**TOWN OF LEESBURG  
TOWN COUNCIL WORK SESSION**

**Subject:** Downtown Improvements Project Update

**Issue:** Should Town Council recommend changes to the approved Downtown Improvement Project?

# Plan A (version 2)

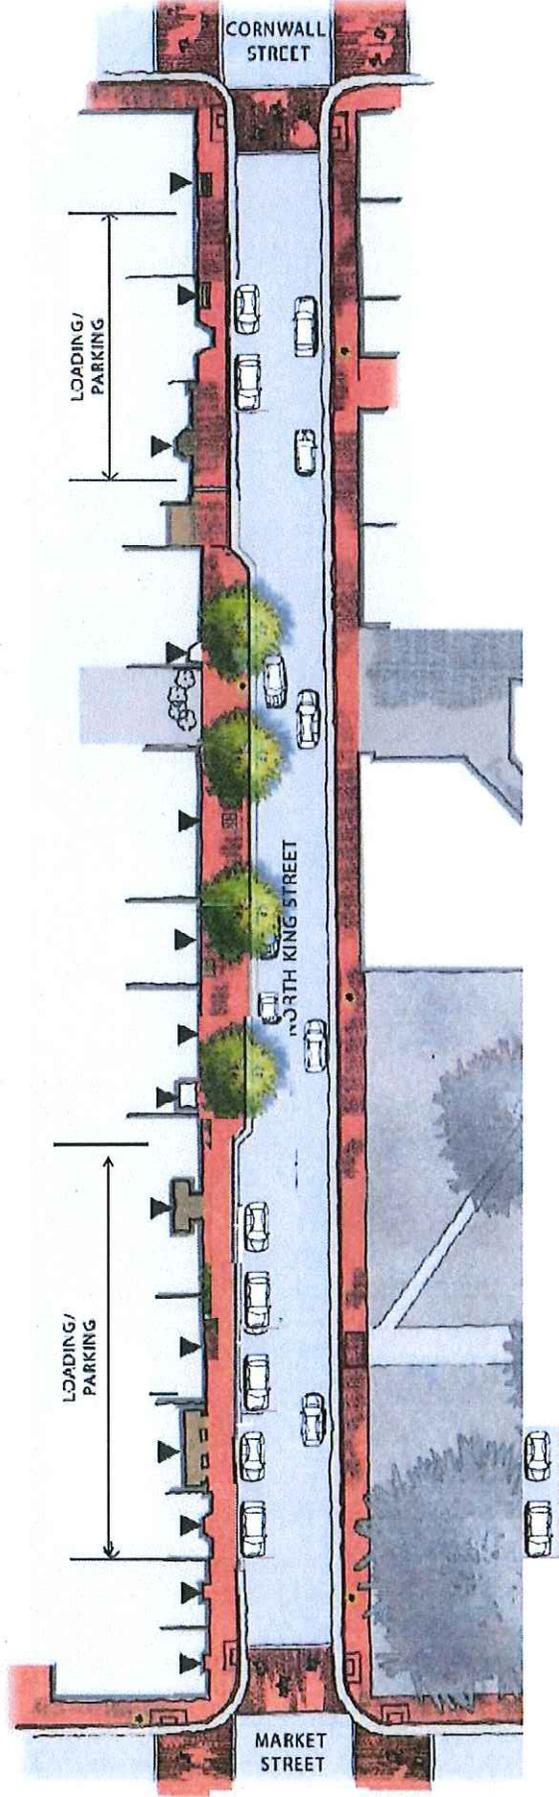
Staff had provided with the previous report a potential amendment to the design that would replace the widened sidewalk in front of the Lightfoot restaurant with an additional 65 to 75 feet of parking area that would return the passenger loading zone in front of the restaurant that was removed with the approved design (attachment 2). Town staff could incorporate this amendment into the design should the Town Council direct staff to do so.

The difference between the plans is that with version 2, staff had moved the widened sidewalk back 65 to 70 feet to accommodate Lightfoot. Since the existing passenger loading is only 44 feet long, we have modified the plan to add back approximately 25 feet of widened sidewalk. Should the Council approve the modification, staff feels this plan accomplishes the following:

# Plan A (version 3)

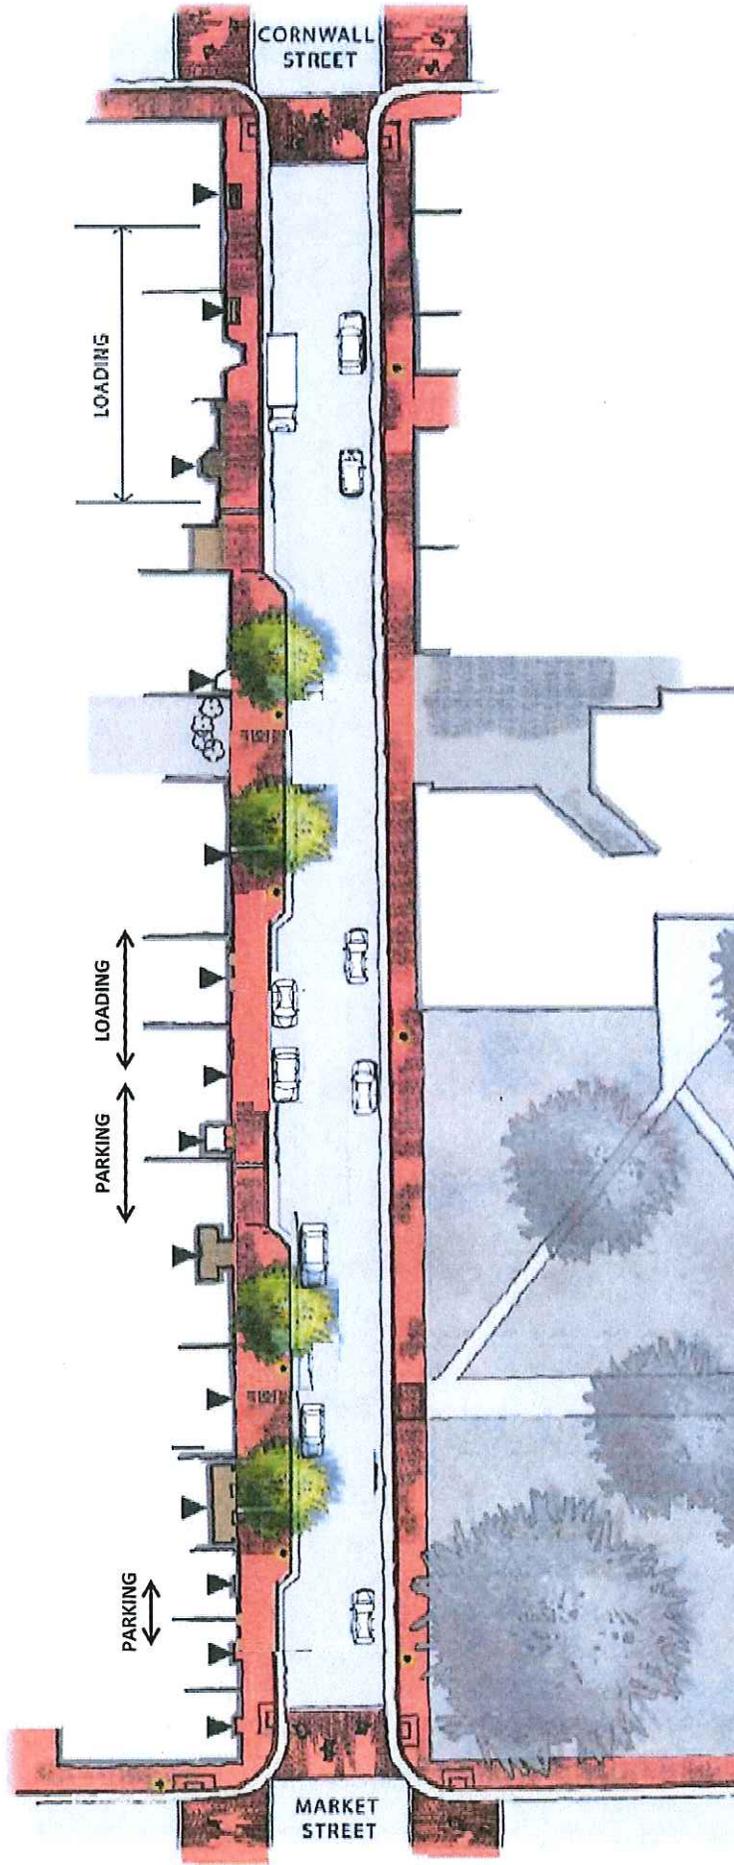
However, at the Council meeting, the representative of the Lightfoot presented a hand drawn sketch that proposed a possible new design. Council directed staff to analyze this design, which in essence creates two areas of widened sidewalks instead of one, with the loading zone in between.

Staff does not endorse the Lightfoot proposal (attachment 3). This design, while helping the Lightfoot, would affect other property owners that have expectations of the approved plan. This alternative plan, while creating a wider sidewalk in front of the Lightfoot Bakery, eliminates the widened sidewalk in front of Shoes, which has endorsed the wider sidewalks. The other property

owner affected is the owner of the building where the Downtown Saloon is located. The original plan had created an expectation of parking in front of his building that will now be eliminated. In addition, this plan creates two areas of widened sidewalks which are inconsistent with the visual impact and appeal of the remainder of the project.

# Plan A (version 4)

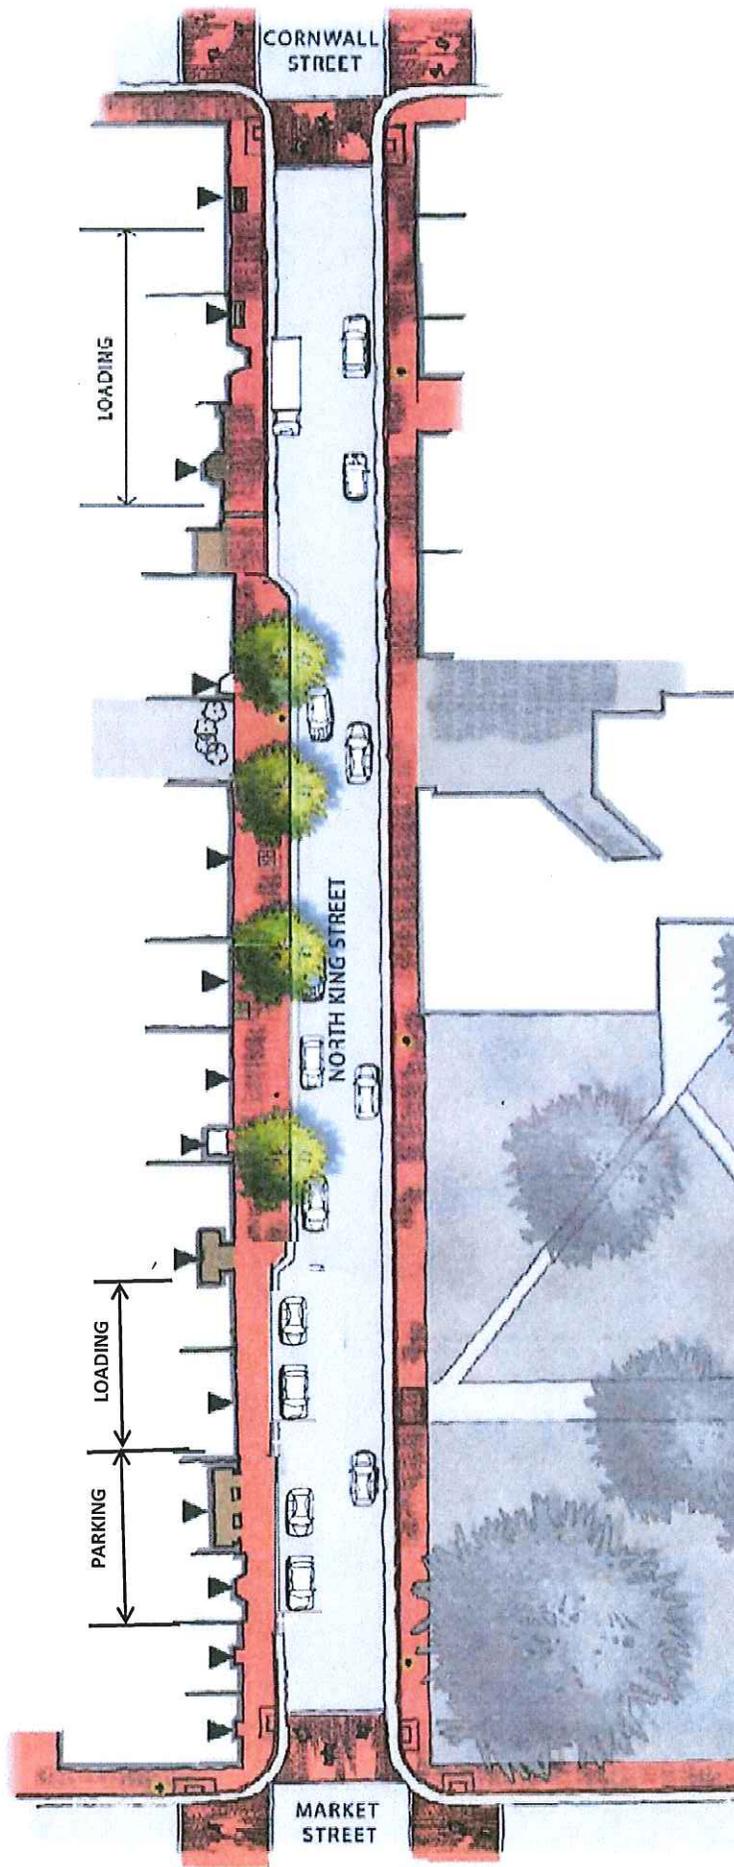
Since the Lightfoot owners stated that they were trying to preserve a condition that was already negotiated, staff has created a plan that preserves the existing condition of the passenger loading zone, does not affect other business and property owners who have an expectation from the approved plan, and maintains integrity of the design. This plan (attachment 4) provides a 44 foot passenger loading zone (as currently exists, comprising two parking spaces) at the south edge of the Lightfoot restaurant and in front of the Lightfoot Bakery. This plan is generally consistent with the plan shown to Council on June 23, referenced as version 2 (attachment 5).

- Accommodates the Lightfoot request for a 44 foot long passenger loading zone during the times of 5:00 pm to 7:00 am as currently exists.
- Does not affect other property owners through this modification.
- Keeps a consistency in the widened sidewalk to a point that makes sense and is visually viable
